**BOARD OF ZONING ADJUSTMENT  
STAFF REPORT****Date: May 4, 2020****CASE NUMBER**

6323

Ahearn Construction (Matthew Ahearn)

**LOCATION**900 Saint Anthony Street  
(Northwest corner of Saint Anthony Street and North Broad Street).**VARIANCE REQUEST****PARKING:** Parking Variance to allow a reduced number of parking spaces in a B-4, General Business District.**LANDSCAPE:** Landscape Variance to waive commercial landscaping requirements in a B-4, General Business District.**TREE PLANTING:** Tree Planting Variance to allow a reduced number of required tree plantings in a B-4, General Business District.**ZONING ORDINANCE  
REQUIREMENT****PARKING:** The Zoning Ordinance requires compliant parking for new commercial development in a B-4, General Business District.**LANDSCAPE:** The Zoning Ordinance requires compliant landscaping for new commercial development in a B-4, General Business District.**TREE PLANTING:** The Zoning Ordinance requires compliant tree planting for new commercial development in a B-4, General Business District.**ZONING**

# SITE PLAN

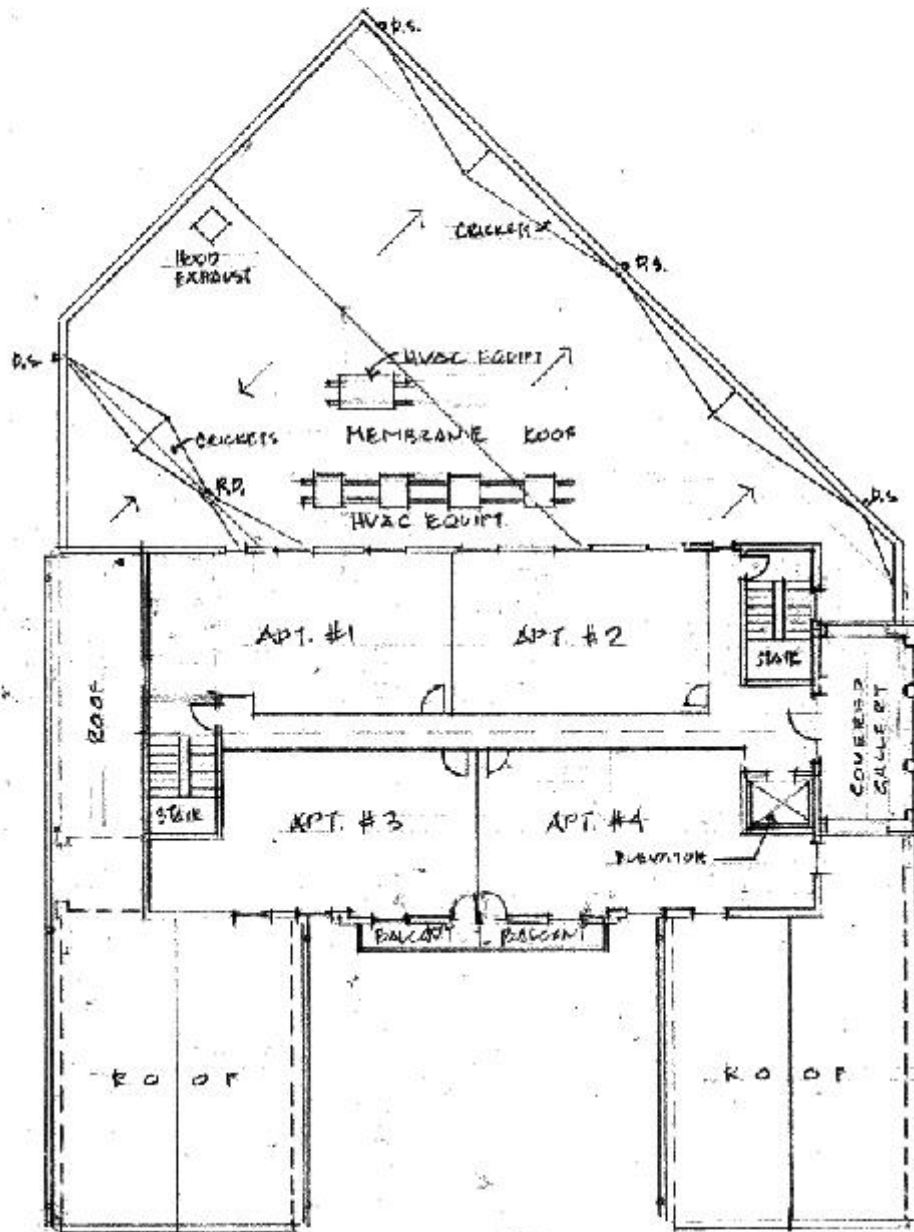
Pertaining to the Parking Variance request, the applicant's calculations for the restaurant and retail use are erroneous, as a 5,314 square-foot restaurant requires 54 parking spaces, and 1,925 square feet of retail space requires 7 parking spaces. The applicant erroneously rounded down on fractional calculations for the two, thereby shorting the requirement by 2 parking spaces. And the required apartment parking is not automatically included in the restaurant parking requirement. As the site plan indicates 4 apartment units, and as residential apartment use parking is calculated at 1.5 spaces per unit, 6 parking spaces would be required for the apartments. Therefore, the total parking required for all uses on the site would be 67 spaces. As 35 spaces are provided on the site plan, the site would be short by 32 spaces. The site would only contain approximately 52.2% of the total parking spaces required. As the site is located within an area which cannot provide on-street parking for commercial purposes, this would constitute a serious and unsafe shortage in parking.

The Zoning Ordinance states that 12% of the total site must be landscaped, with 60% of that 12% being street frontage landscaping. The site plan provided does not contain any landscaping calculations. However, as the site contains approximately 0.51 acre (22,216 square feet), a 12% landscaping requirement would equal approximately 2,666 square feet of total site landscaping. A street frontage landscaping requirement of 60% of that total would be approximately 1,600 square feet of street frontage landscaping required. However, as the site plan indicates a build-out to the North Broad Street and State Street frontage property lines, no street frontage landscaping can be provided in these areas. Only a small area along the State Street frontage of the parking lot and along the Saint Anthony Street building frontage are landscaped. A narrow landscaping strip is provided along the West boundary of the site, but no calculation for its area is provided.

The applicant only addresses parking trees in the narrative, and states that 2 understory trees would be required. However, as the site actually requires 67 parking spaces, 4 understory parking trees would be required. No calculations are provided for the required frontage trees or perimeter trees. It is stated that there is 1 tree located with a parking lot island, although its size and species is not provided. It is also stated that there would be 4 trees located within an interior courtyard, but again, no species is given.
